**In Response to CEC & BLM Data Requests 128-141
Set 2, Part 1
Application for Certification (08-AFC-5)
SES Solar Two, LLC**

Subject: SES Solar Two (08-AFC-5)
Responses to CEC and BLM Data Requests 128-141
URS Project No. 27657106.00608

SES Solar Two
In Response to CEC and BLM Data Requests
Set 2, Part 1
Data Requests 128-141
08-AFC-5

FIG. NO:
134-1

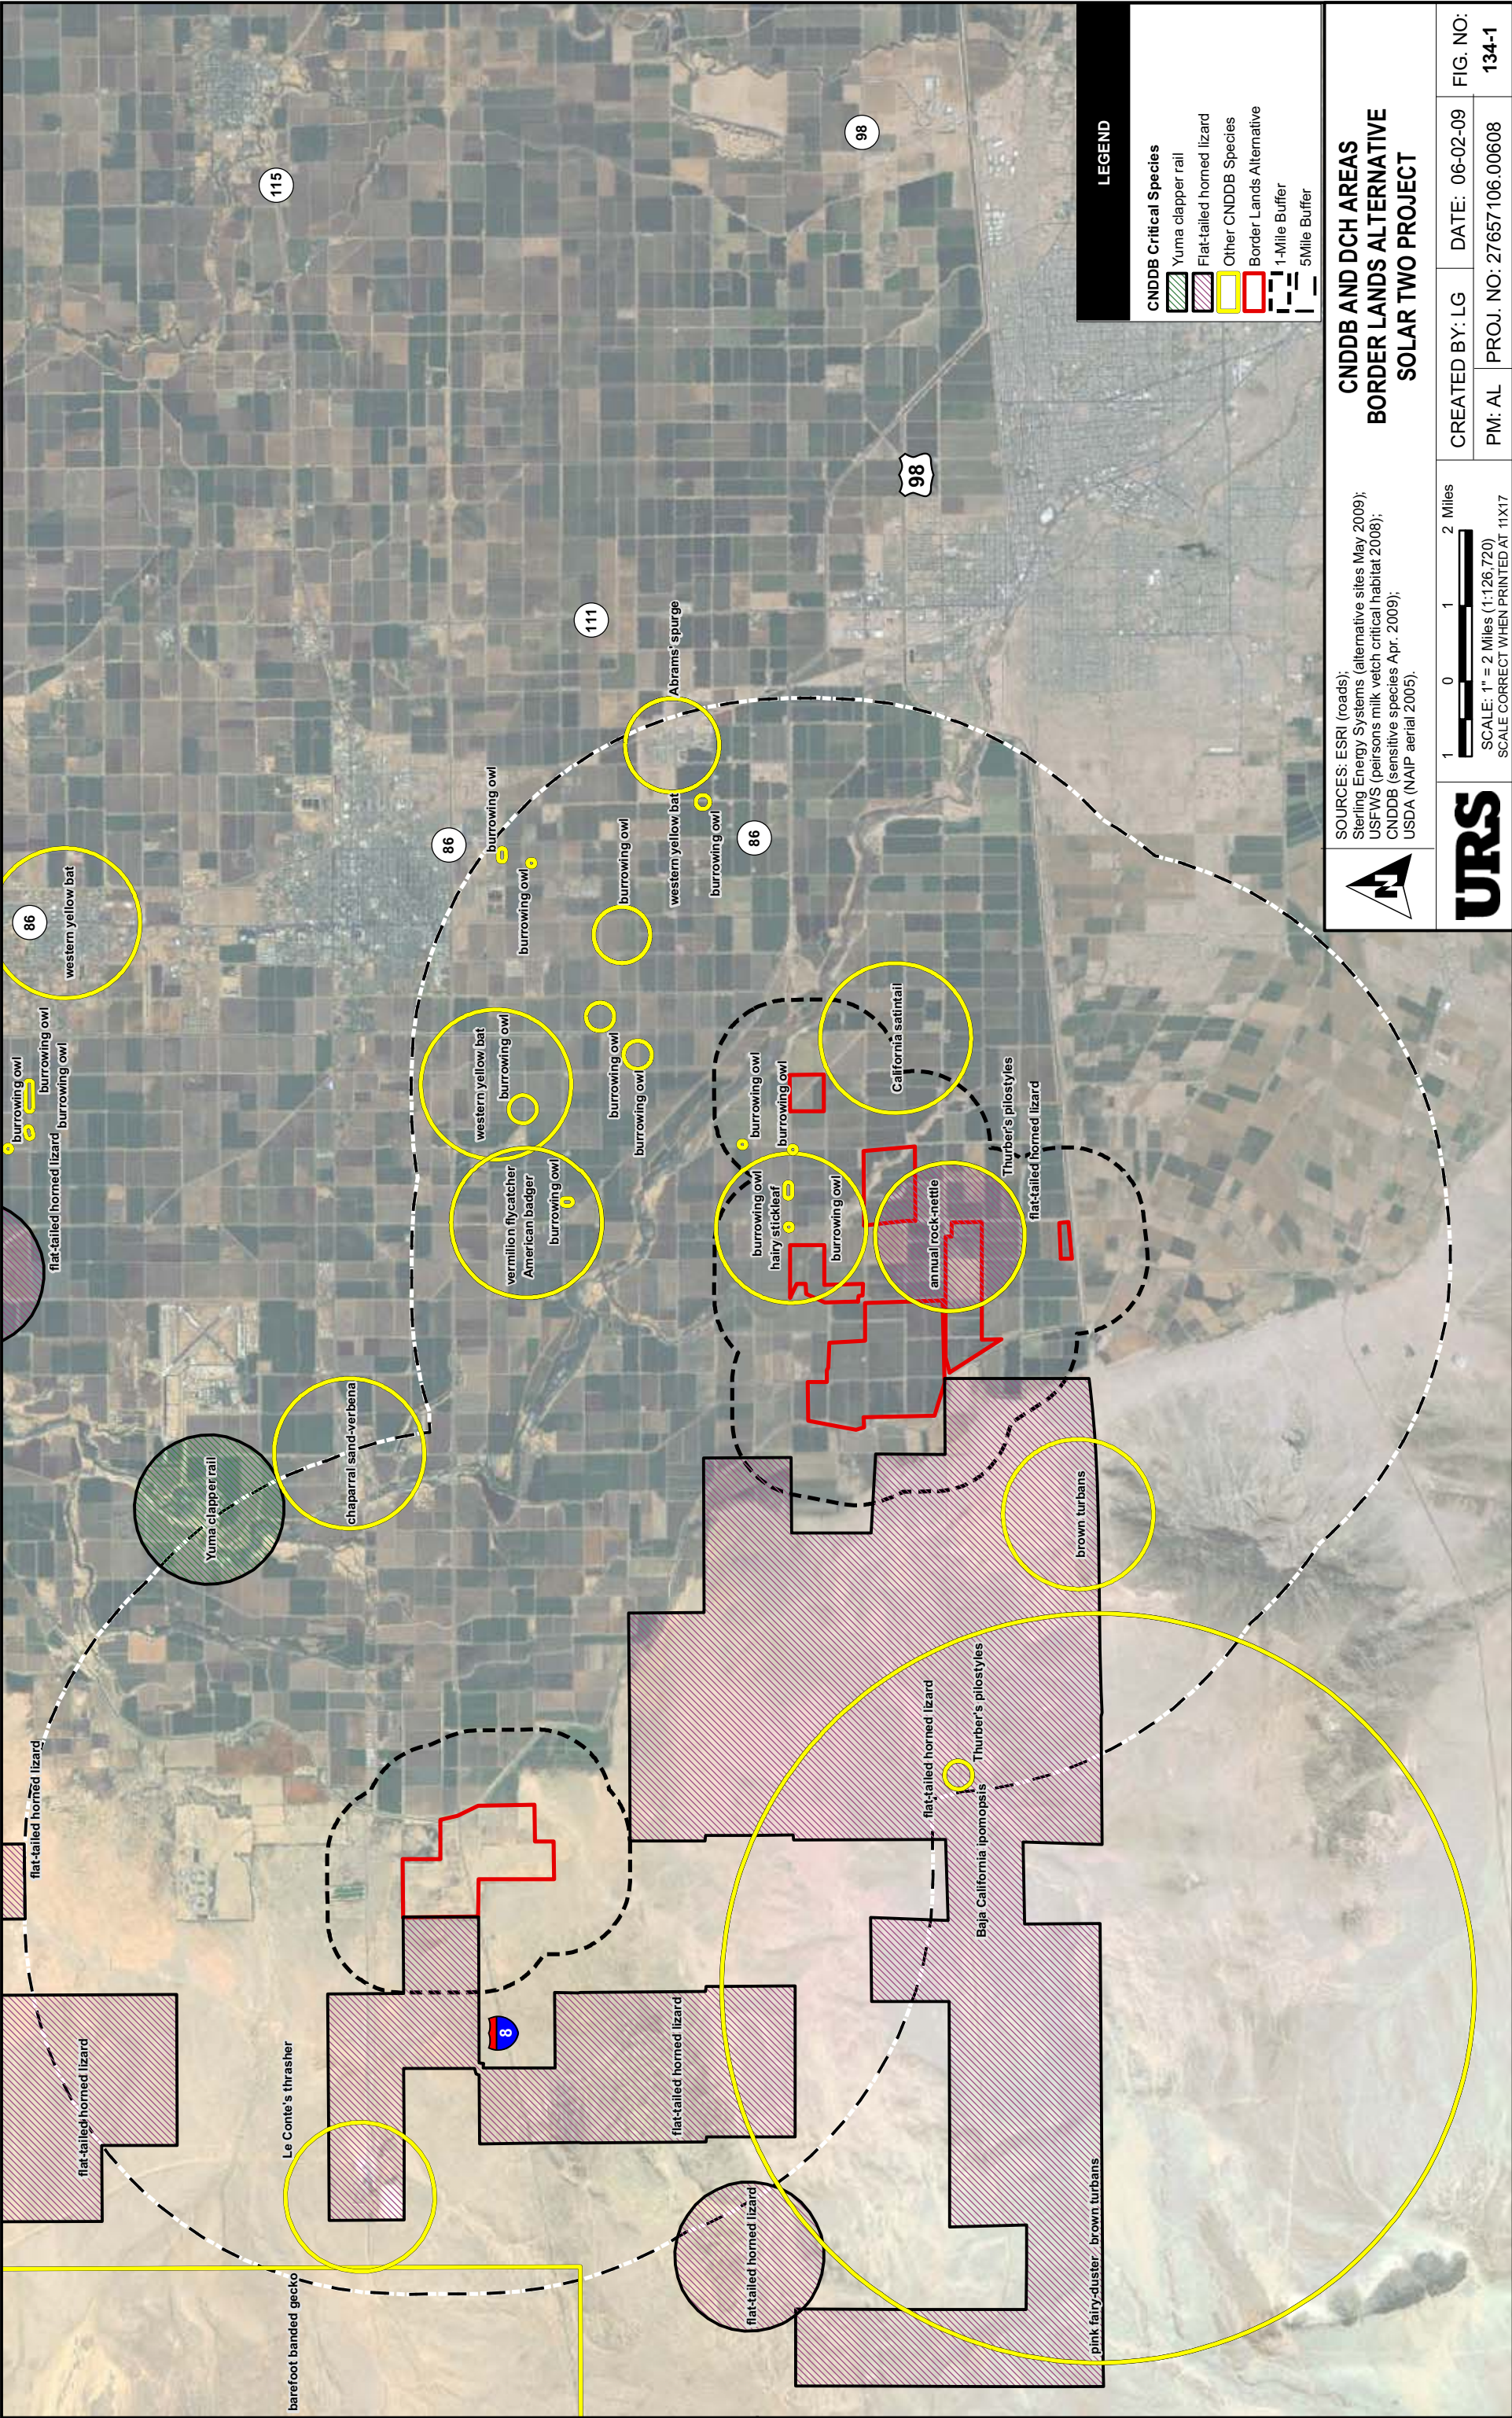
- **Biological Resources:** One of the site selection criteria for the proposed SES Solar Two site was to avoid highly pristine or biologically sensitive areas. In order to assess this criterion for the alternative sites, please provide the results of the CNDDDB search for the South of Hwy SR 98 site, the Mesquite Lake Alternative, and the Border Lands Alternative.
- **Cultural Resources:** Due to the extensive cultural resources present at the proposed SES Solar Two site, alternative sites are being sought that may impact fewer cultural sites while still achieving the required site criteria. Please provide an Information Center search (Class I) for recorded sites identified within the potential South of Hwy SR 98 site, the Mesquite Lake Alternative, and the Border Lands Alternative.

Border Lands Alternative

The primary land cover of this alternative is active agricultural lands. Burrowing owl is known to occur in the vicinity. Extensive flat-tailed horned lizard habitat occurs about 1 mile west of the site. Rare plants known from the immediate vicinity include annual rock-nettle (*Eucnide rupestris*; CNPS List 2), hairy stickleaf (*Mentzelia hirsutissima*; CNPS List 2), Thurber's pilostyles (*Pilostyles thurberi*; CNPS List 4), and California satintail (*Imperata brevifolia*; CNPS List 2). A major drainage is apparent in the eastern portion of this alternative. Please see Figures 134-1 and 134-2, provided behind this response as attachments BIO-2 and BIO-3, respectively.
